RE: **SAD 227 lot 6-1A Block 12, Volcano Cliffs Unit 5**
6520 Jade Dr. NW
Grading and Drainage Plan
Engineers Stamp Date 8/17/17 (E10D032)

GRADING & DRAINAGE PLAN

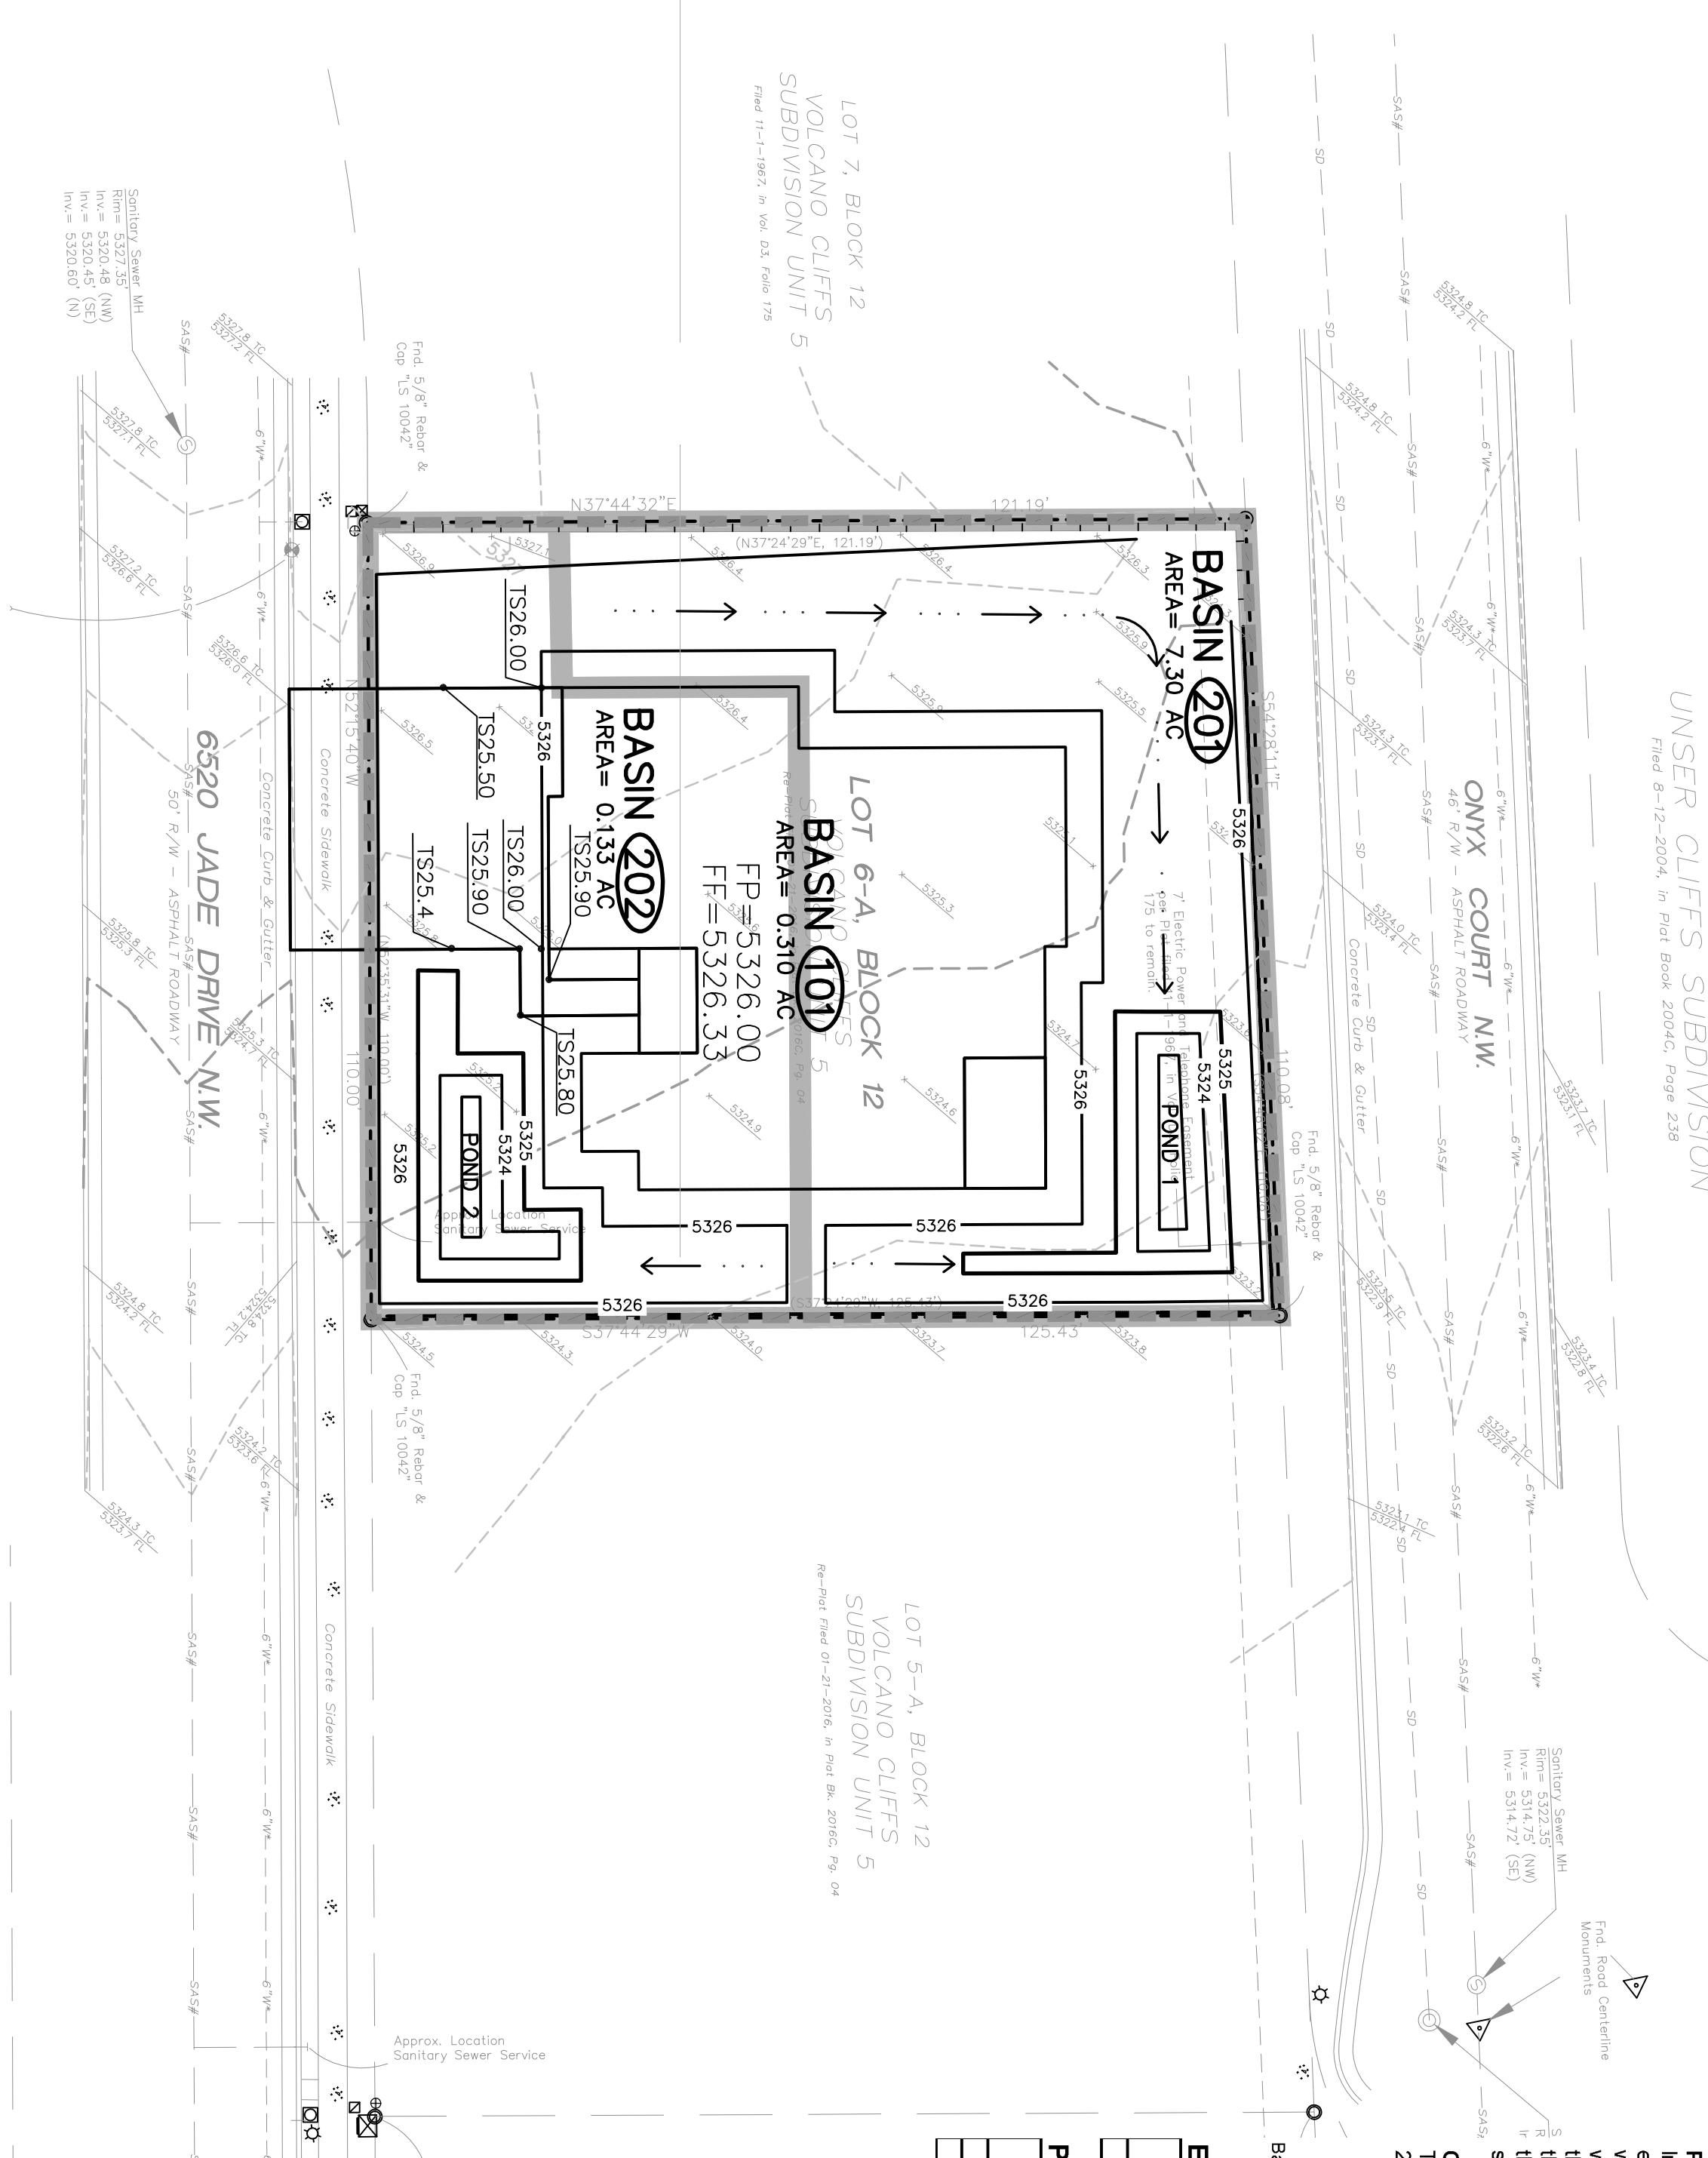
Based upon the information provided in your submittal received 8/18/17, this plan is approved for Grading Permit. Please attach a copy of this approved plan to the construction sets in the permitting process prior to sign-off by Hydrology.

Prior to building Permit approval a pad certification is required.

Prior to Certificate of Occupancy release, Engineer Certification per the DPM checklist will be required.
